## Reissued/Amended Certificate of Appropriateness

132 E. LLOYD ST.

PTS ID 20752 COA, Exterior rehabilitation.

**Existing condition of house as of 9/20/2007.  
South and east elevation.**

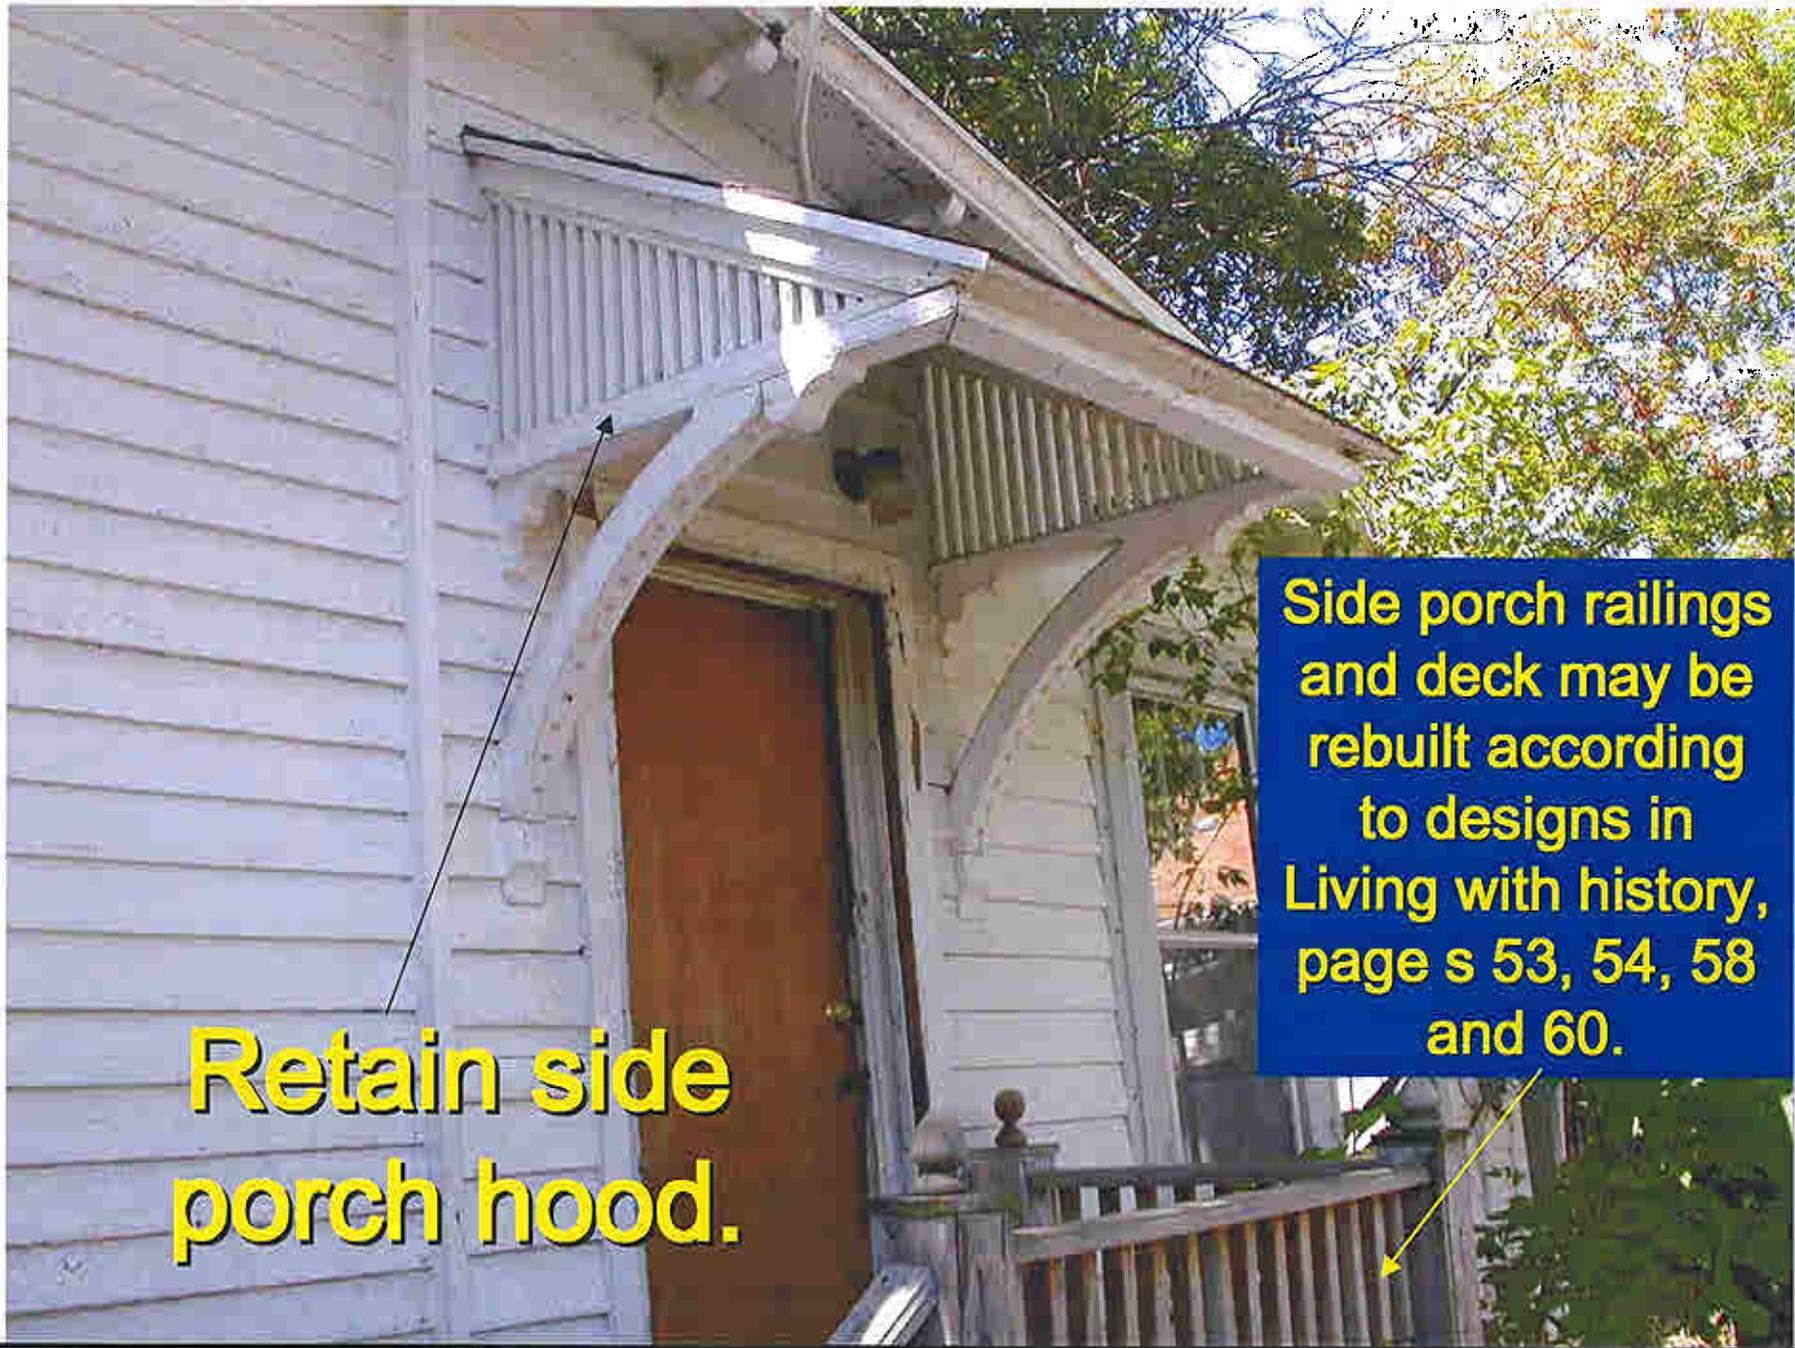
**Remove enclosed front porch and replace with new front porch stoop.**

**Remove bushes and trees from front lawn, install new concrete steps and plant new grass on berm. Condition in September**

**Restore round gable window as originally built.**

**Original casement  
windows, ca.  
1855-65, remain  
on side and front.**

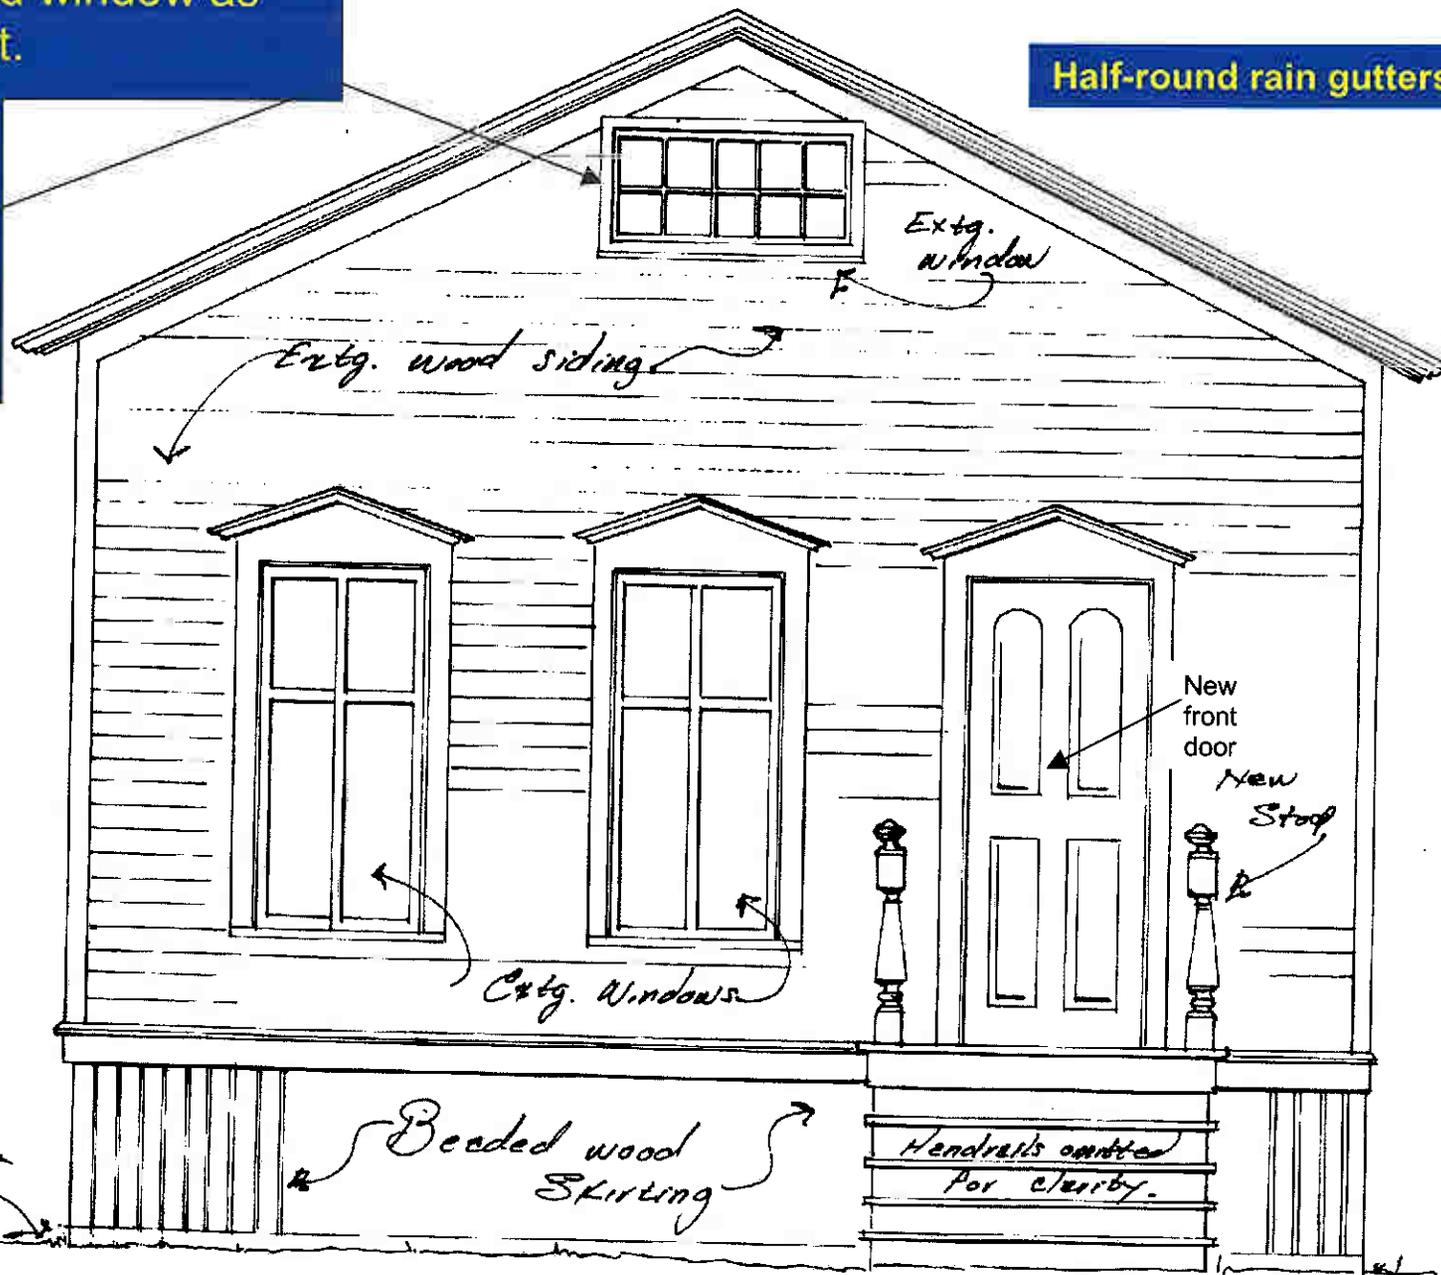
**Retain / repair ALL original casements.**

**Aluminum storm windows  
will be removed and  
replaced with wood storm  
windows that match the  
configuration of the muntins  
in the prime windows.**

**Retain side porch hood.**

**Side porch railings and deck may be rebuilt according to designs in Living with history, page s 53, 54, 58 and 60.**

Restore round window as originally built.

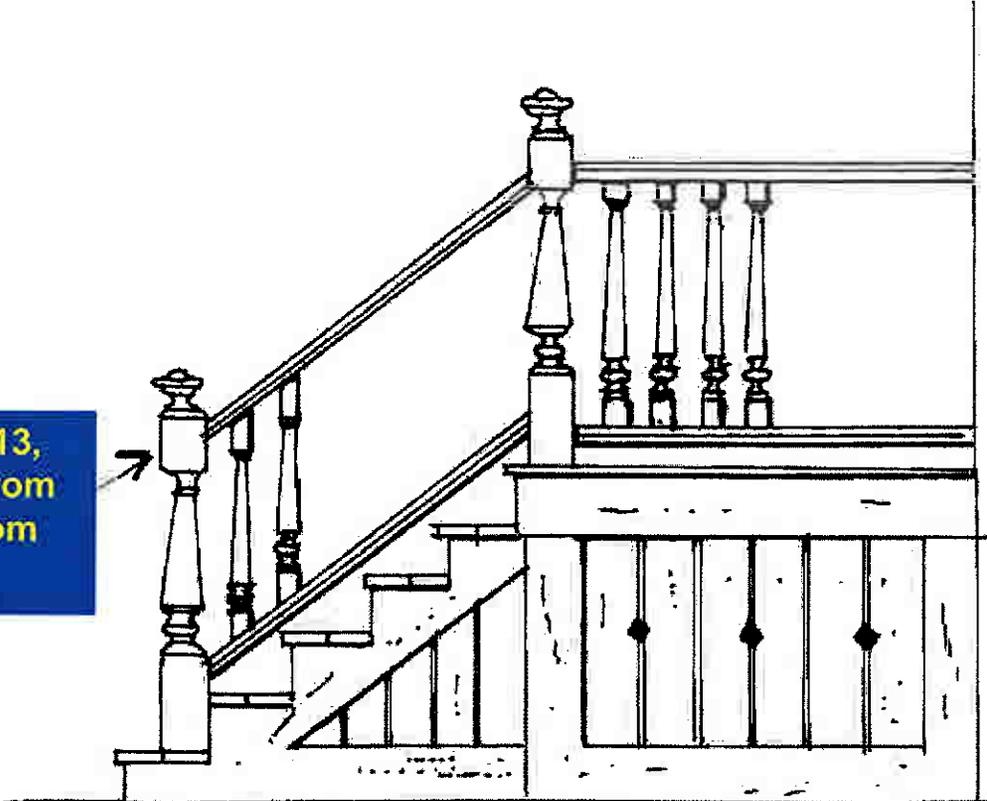
Half-round rain gutters only

Beeded wood Skirting

**New front stoop  
East Elevation**

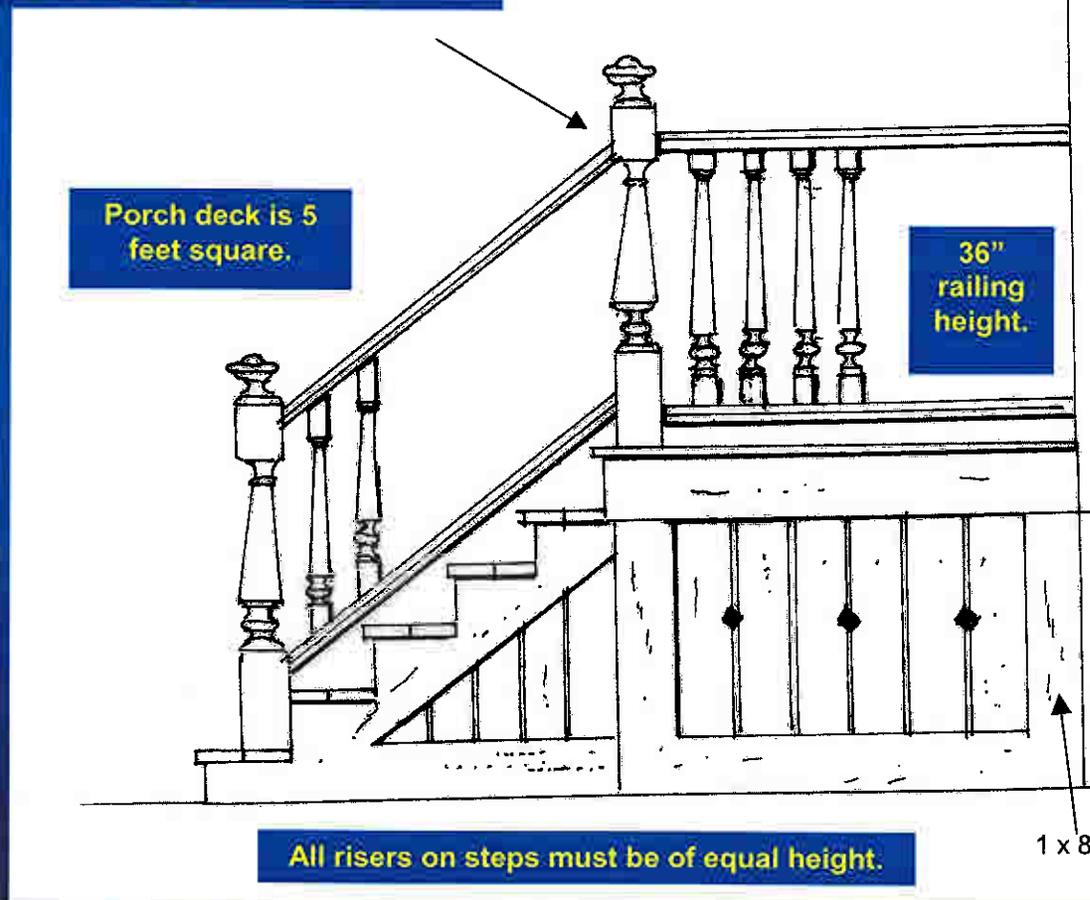
Newel post #13,  
6 x 6 square from  
cinderwhit.com

Spindles are design #9,  
3" square from  
cinderwhit.com

Top and bottom rails are  
design #4 from  
cinderwhit.com

Porch deck should be made of IPE  
wood.

All new wood trim must be clear and  
free from knots and sapwood, and  
be naturally decay resistant (i.e.  
cedar, redwood, cypress)

**Note: bottom of post should extend all the way to grade.**

**Side elevation of new front porch.**

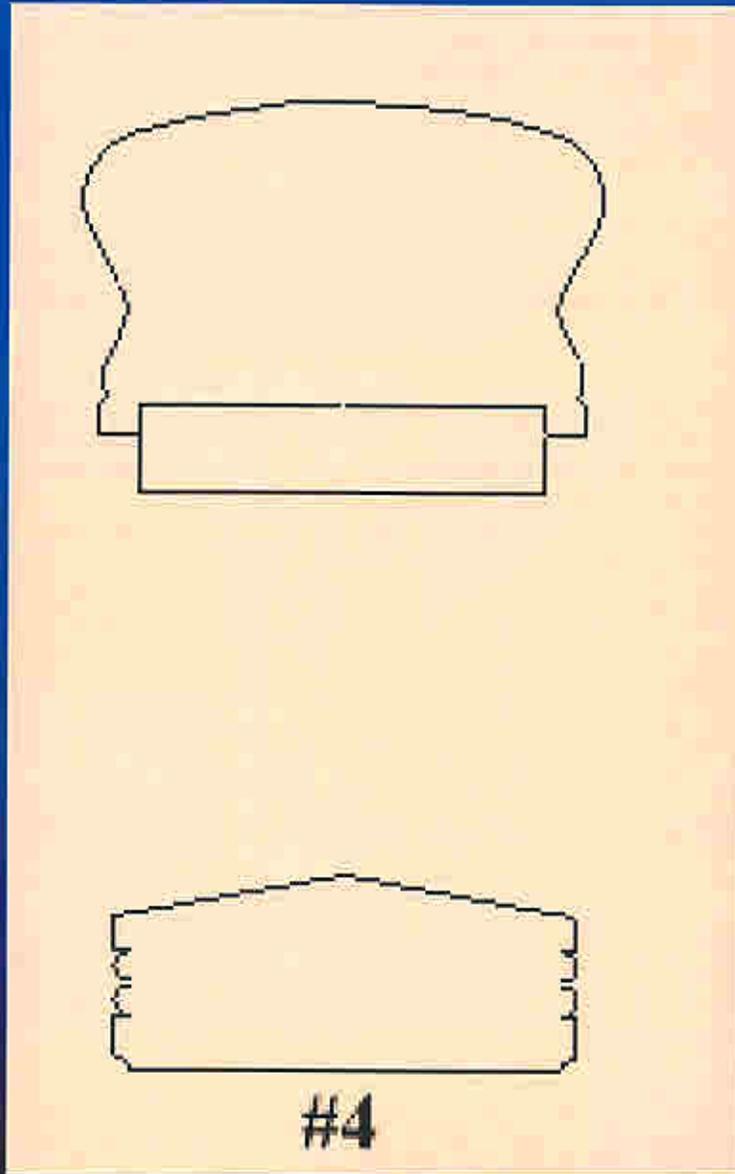
**Spindles 2-3/4" apart and approximately 3" square must be cinderwhit.com design #09.**

**Skirting for side porch.**

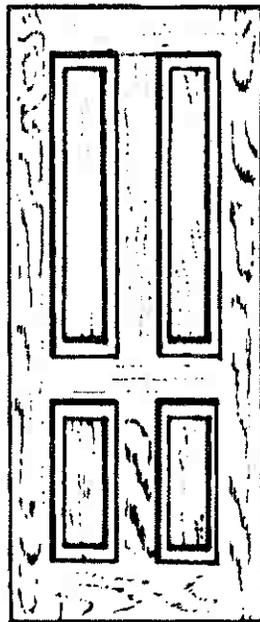
Skirting, such as this lattice panel, enclosed the area beneath the porch floor. It should always be installed with a continuous board frame around it that is wide enough to cover the rough framing lumber that supports the porch deck.

Do not install a lattice skirting without a frame around it. The rough framing lumber that supports the porch will show through and the raw edges of the lattice look unfinished.

*Traditional door designs*

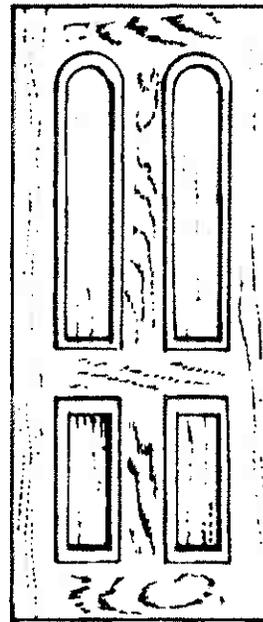
Front and side door will be replaced with a period-appropriate door such as one of these from page 25 of *Living with History*.

A full view wood storm door may be installed over the prime door.
